City of Sugar Creek

Addendum No. 1

RE: Lewis and Clark Expressway – Sterling Ave. Project
Sugar Creek, Jackson County
Federal Aid No.: DP-3400(408)

6 Section - Round Seat
A1 1 1/2" = 1'-0"

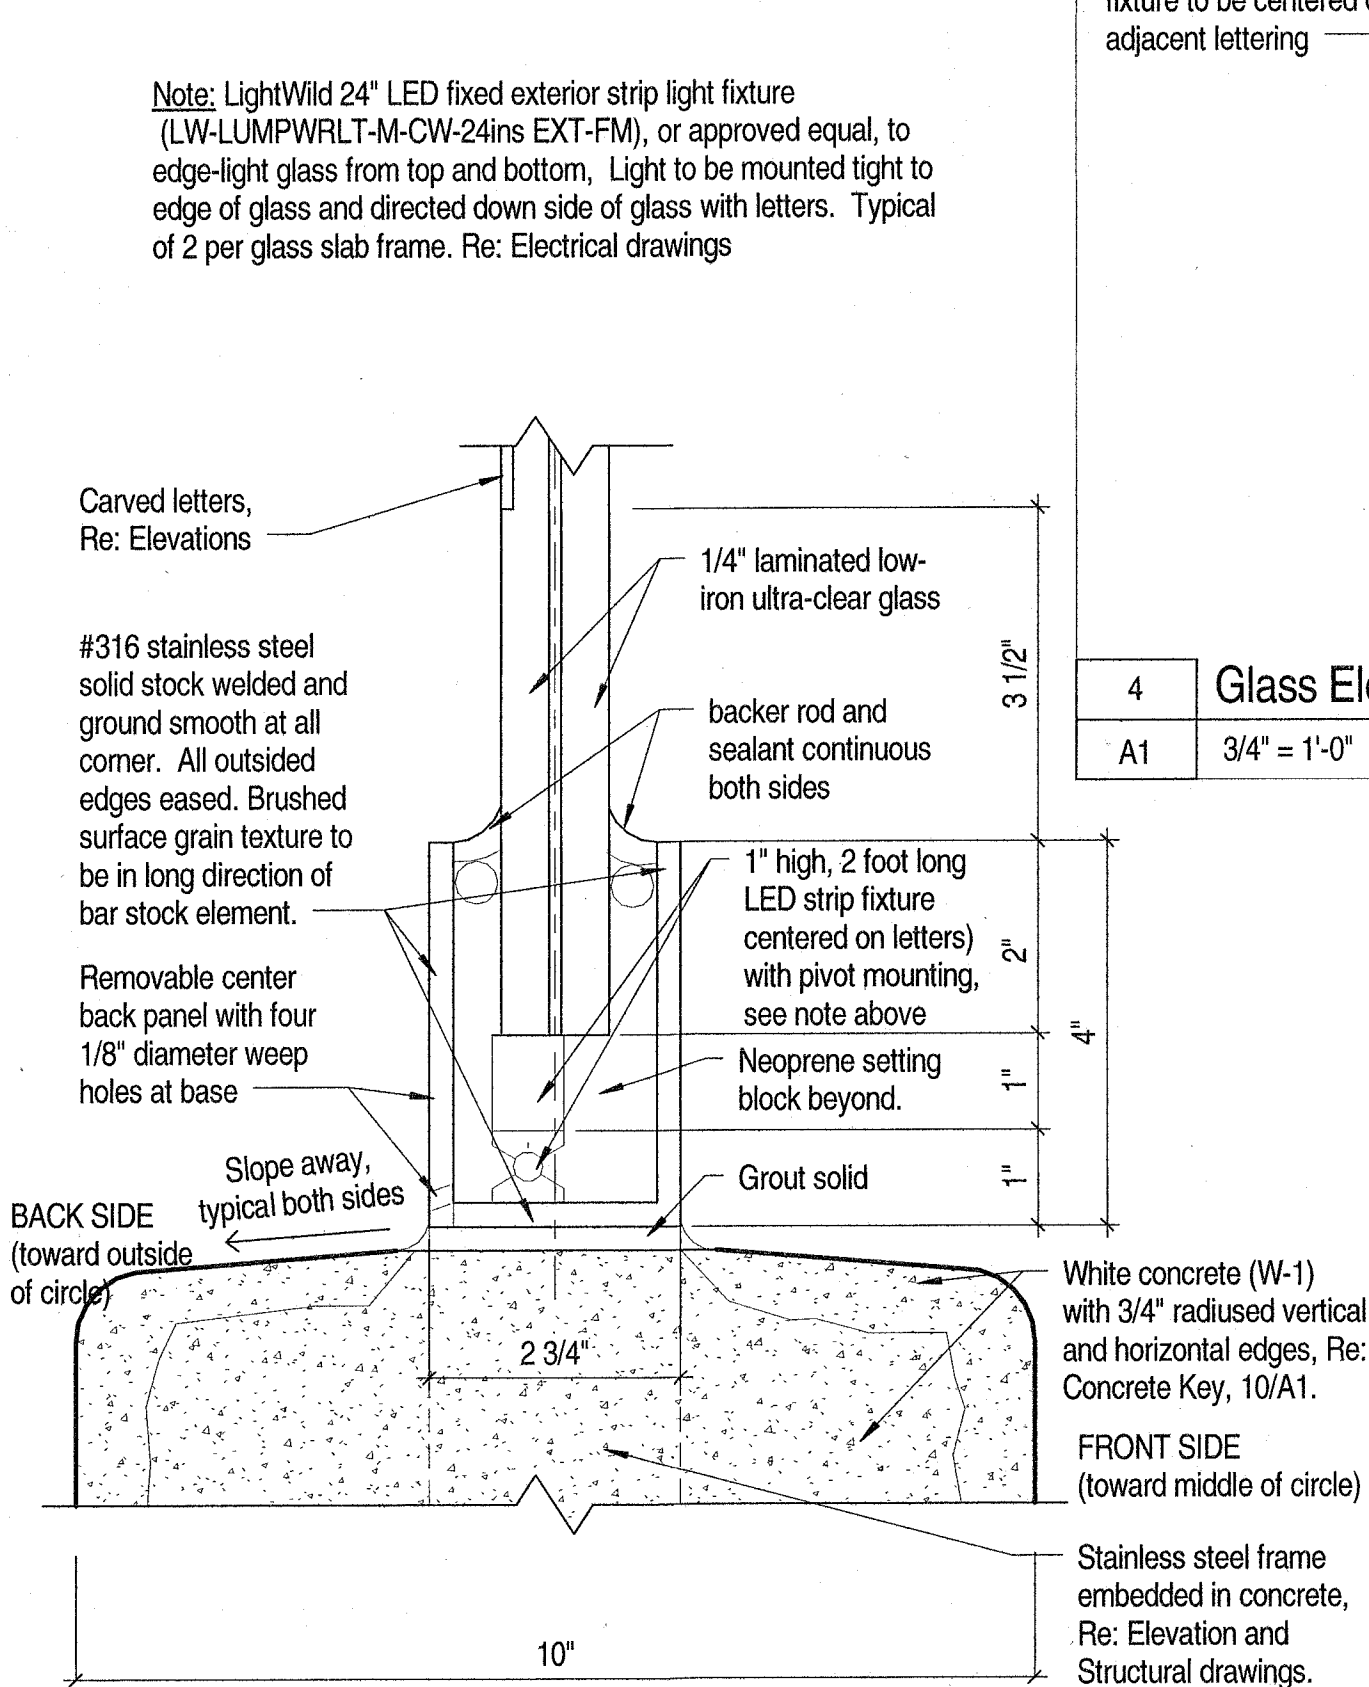
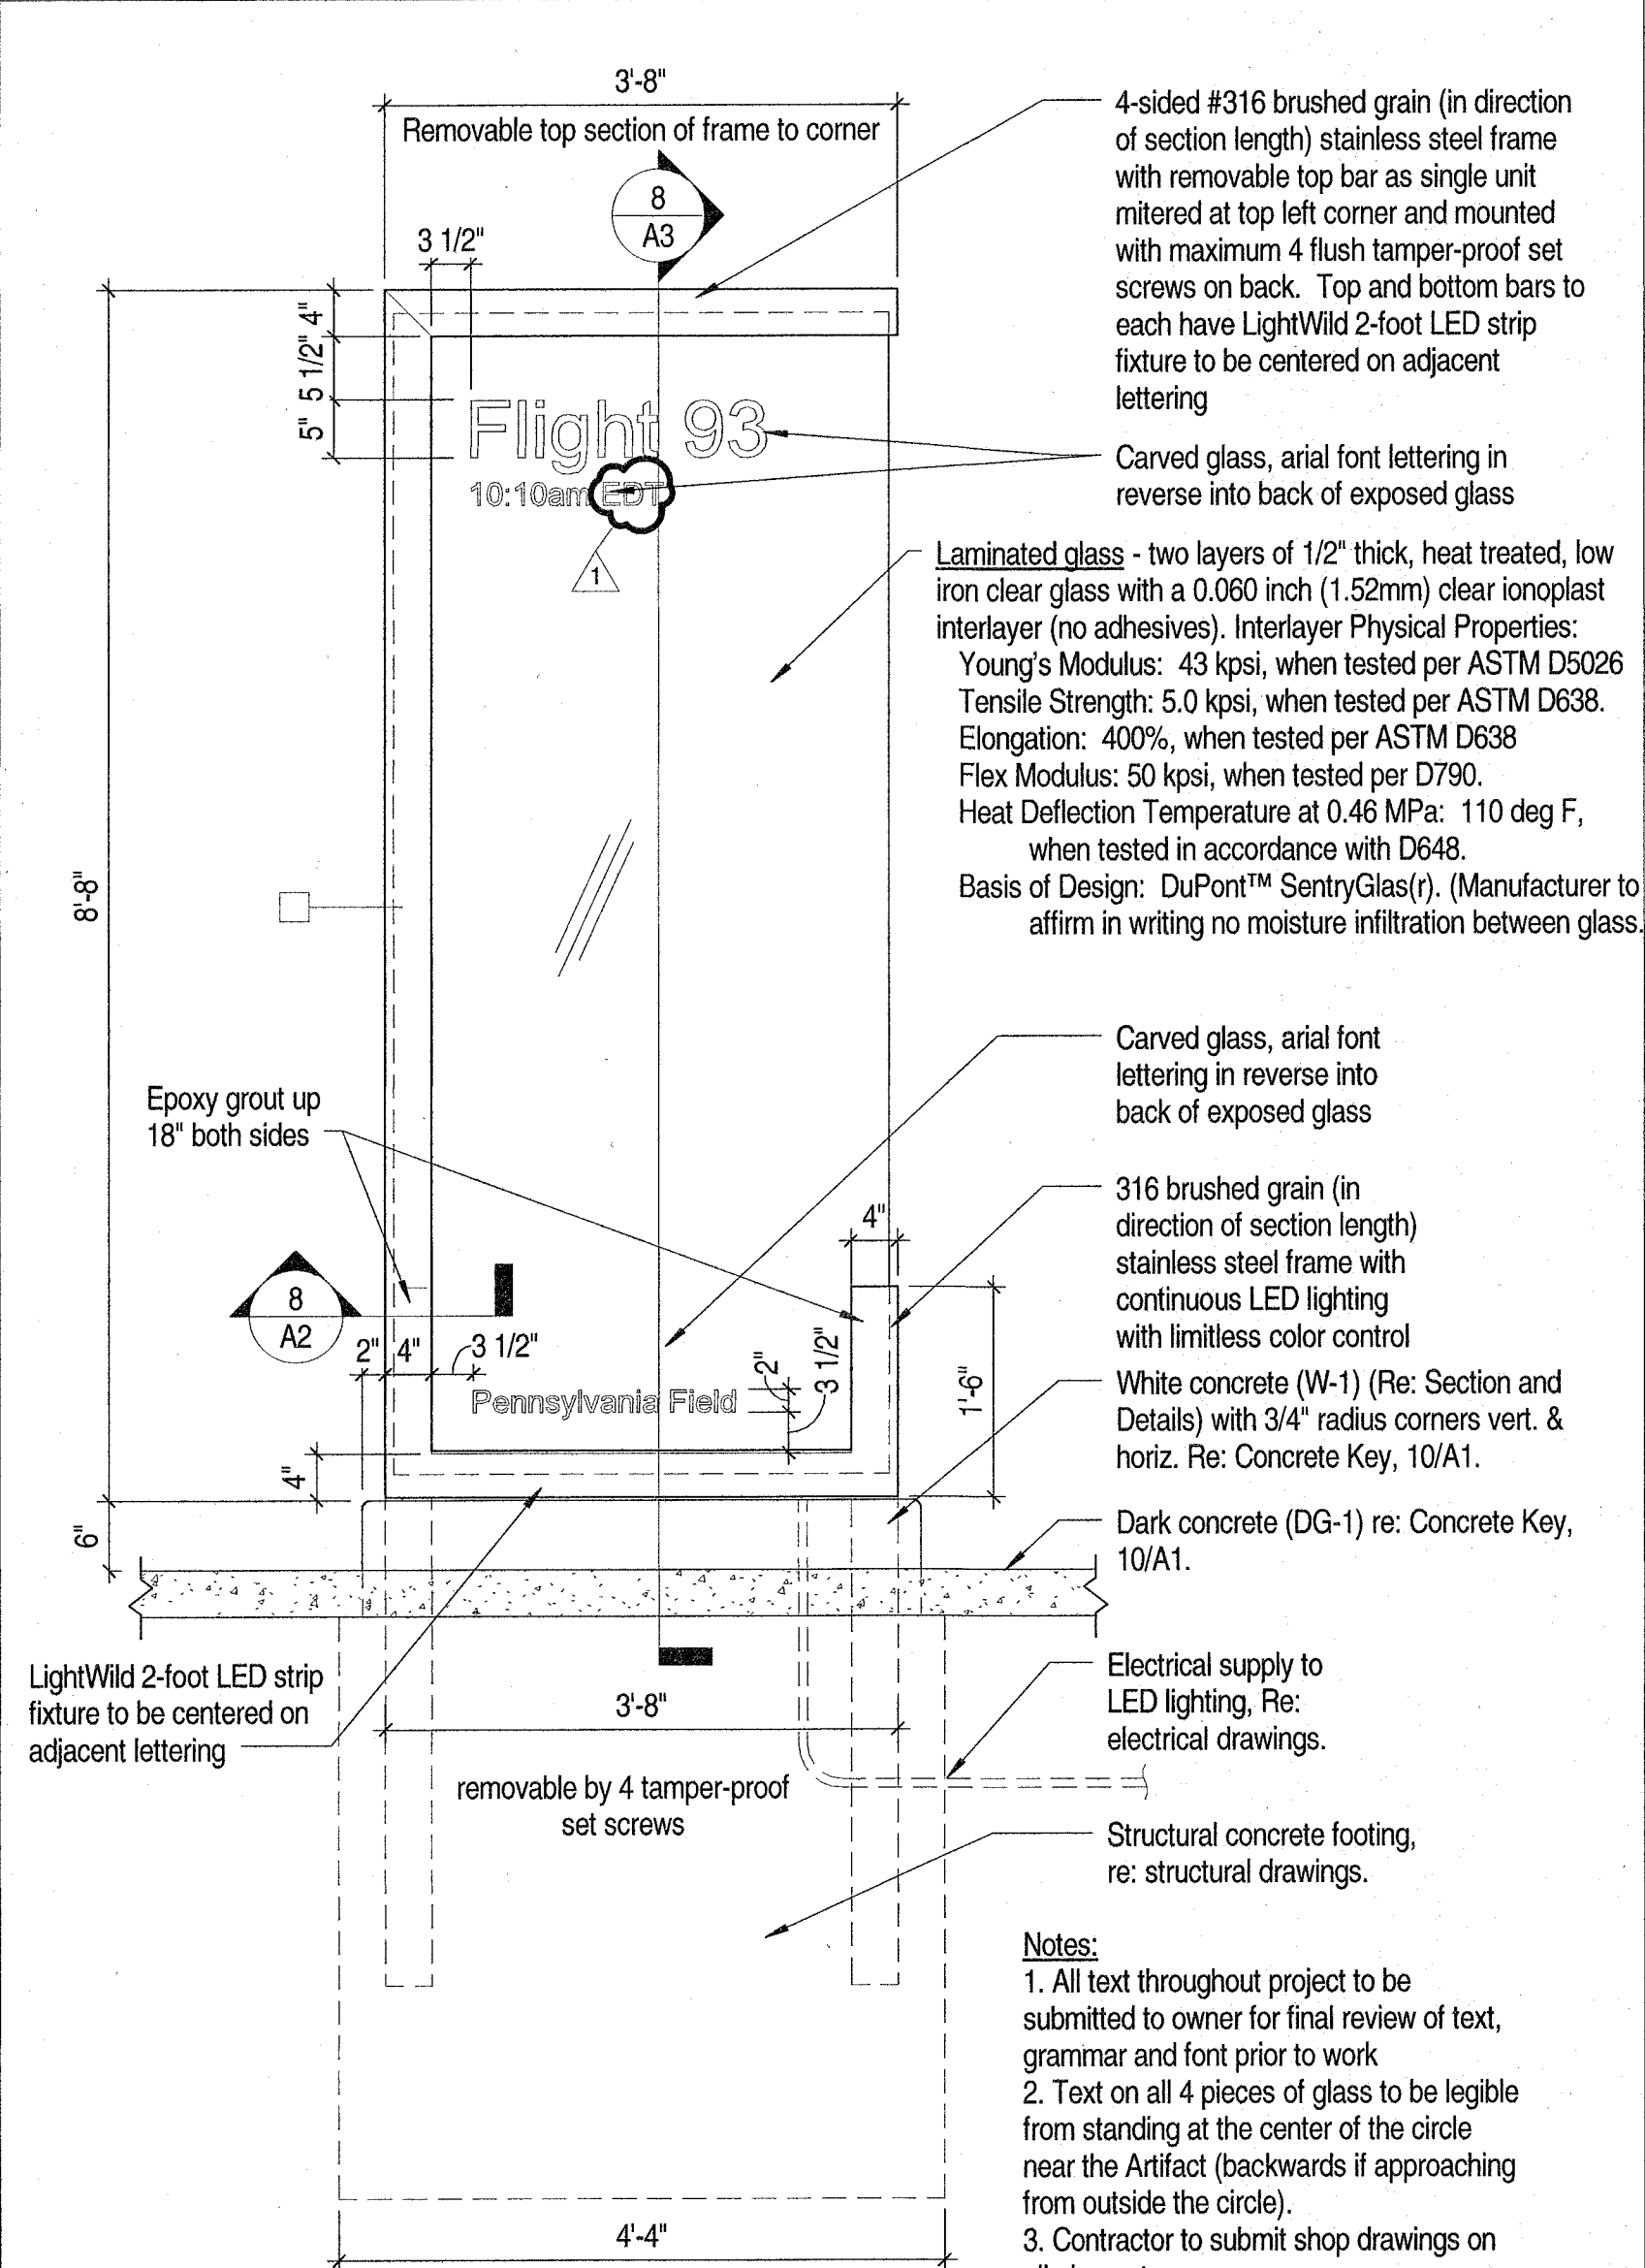
- c. A2 Glass Slabs and Seat Walls (Plan Set Sheet No. 59) – The drawings incorrectly indicated the time zone as being “EST” instead of the daylight savings time zone as “EDT”. The revised detail sheet is attached as 059_0A2_LCE_911DTL.PDF.
